ADDENDUM NO. 3

UNIVERSITY OF CONNECTICUT HEALTH CENTER FINANCE CORPORATION
 AMBULATORY CARE CENTER (ACC) FIT-OUT
 Farmington, CT

UCHC Project No. 11-042
 DCC Project No. 527-2

DRAWING TITLE: SECURITY DETAIL SHEET

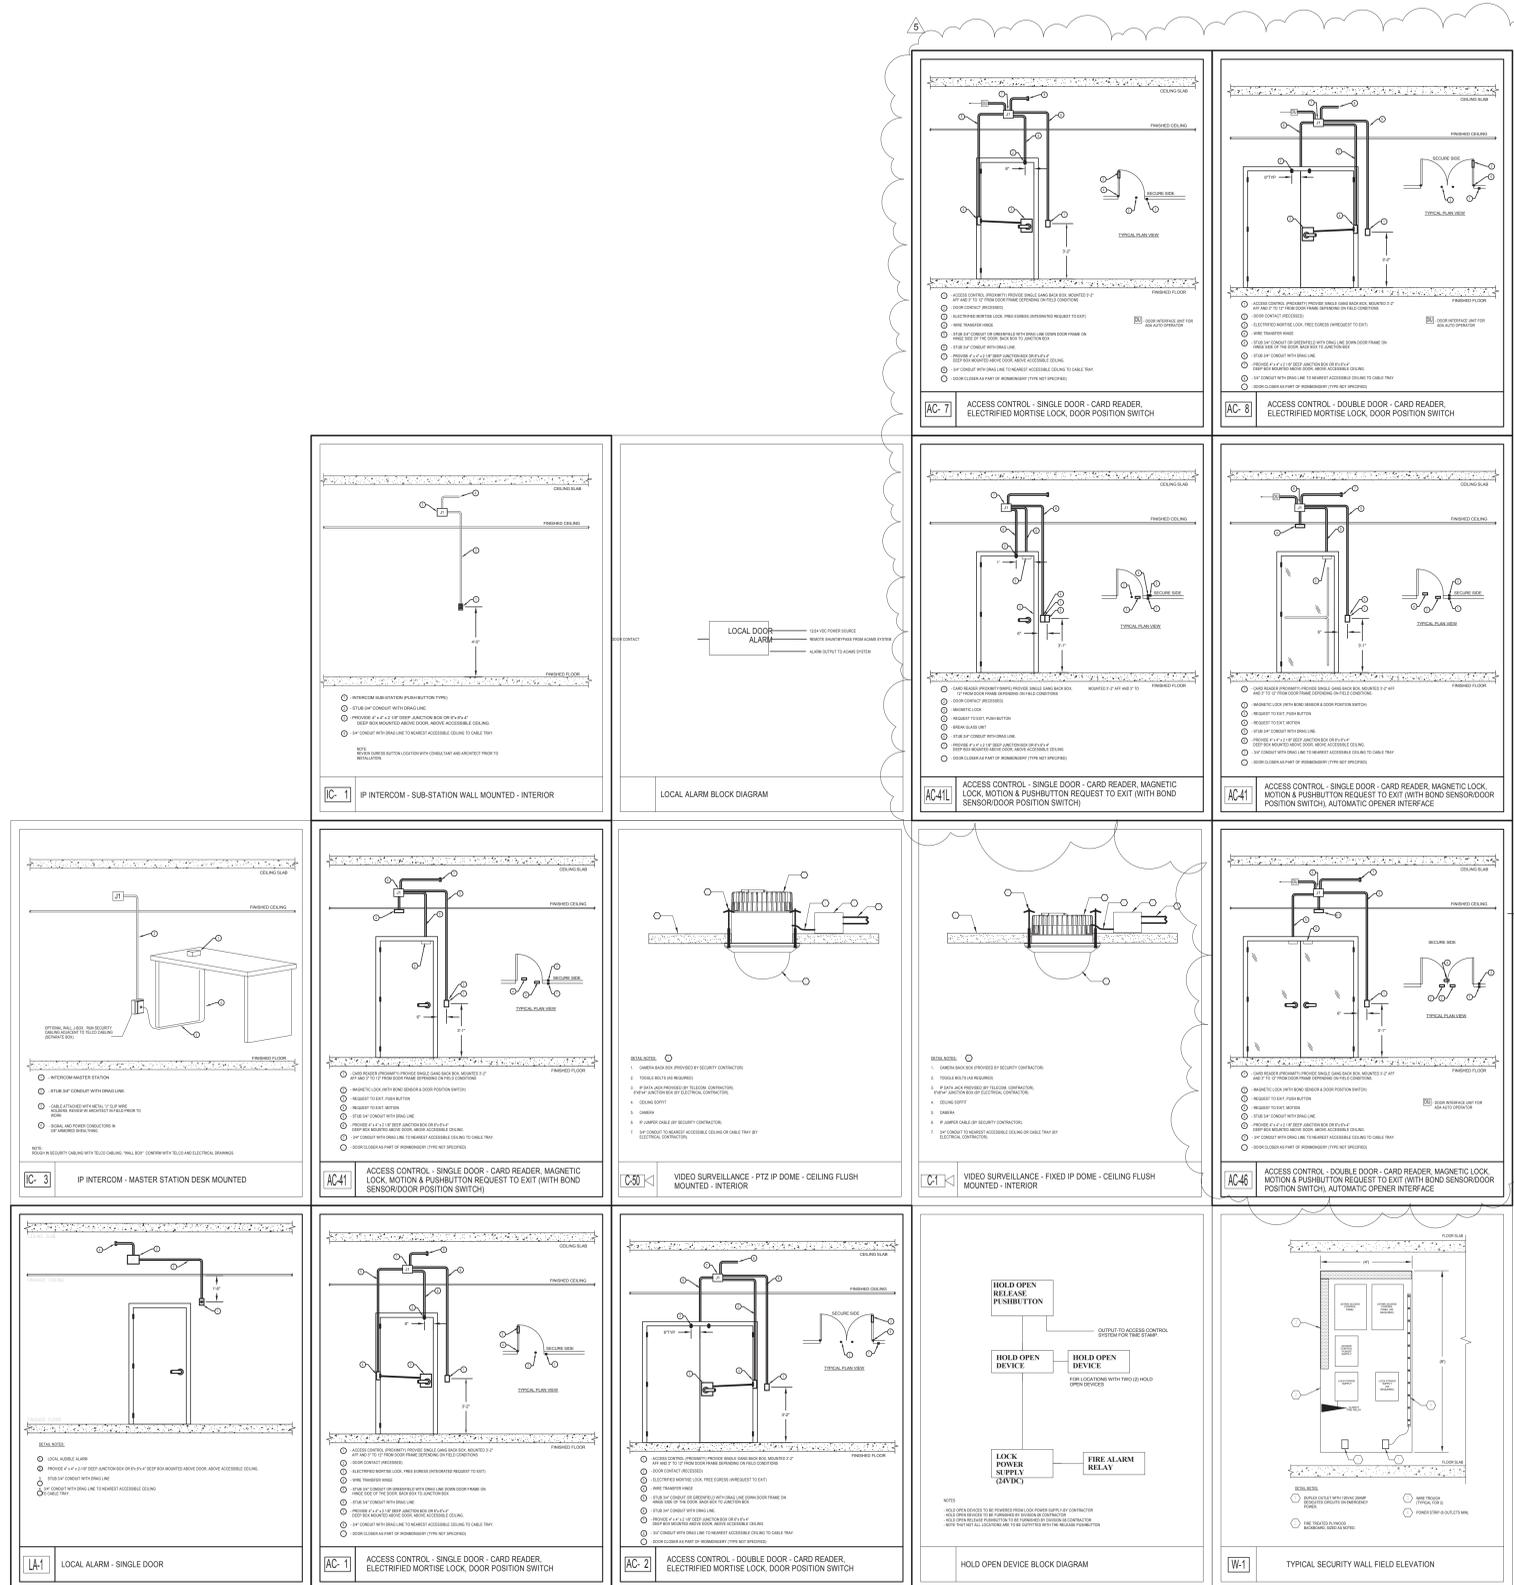
TITLE: Drawing TY-401

Drawing TY-401 was not issued with the Construction Set of Drawings. Please provide this drawing.

Drawing is attached TY-401
